Rezoning Transportation Analysis

Petition Number: 2017-100

General Location Identifier: 05917204

Revision Log:	Date	Description
	07-12-2017	First Review

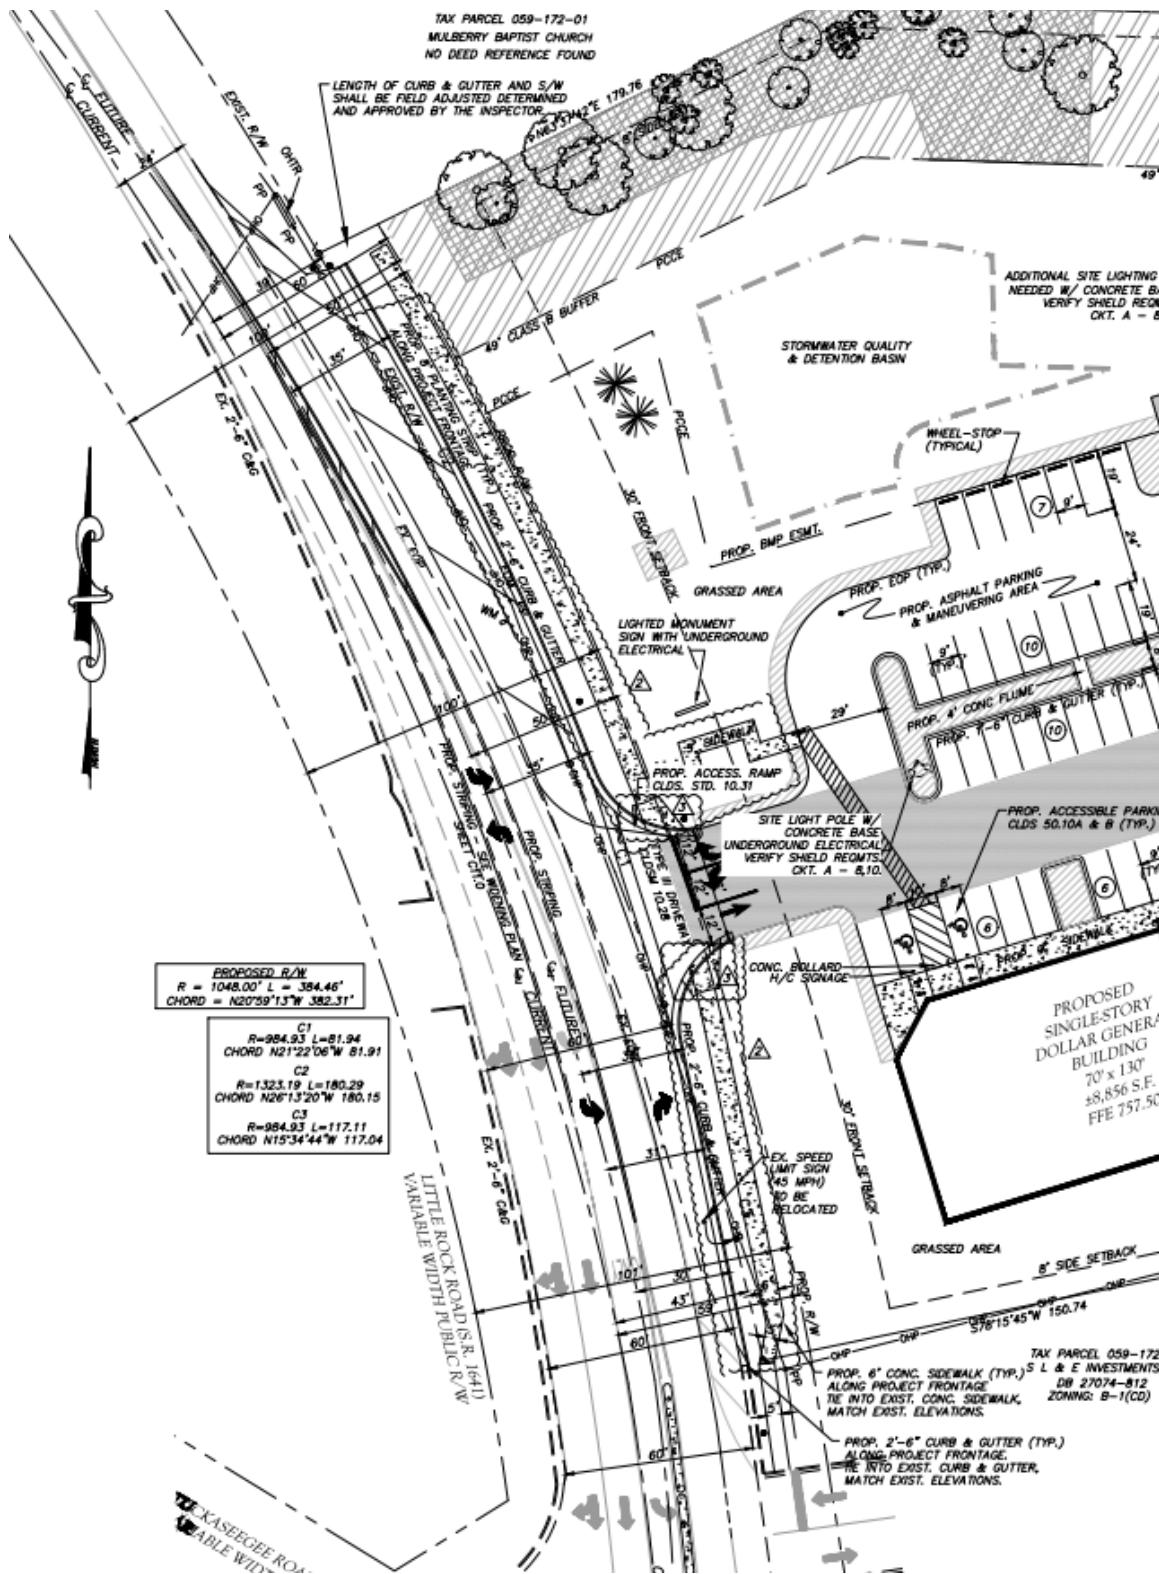
1. ~~Traffic Study~~ A Traffic Impact Study/Transportation Technical Memorandum is not needed for the complete review of this petition.
2. The petitioner should revise the site plan and conditional note(s) to confirm to approved plans LDC-2014-00072 (contact Mitchell Latham at LWE, 704-507-4877) and the City's Little Rock Sidewalk Project (contact Derrell Poole, 704-353-1794). These improvements should be transferred and constructed by this proposed rezoning.
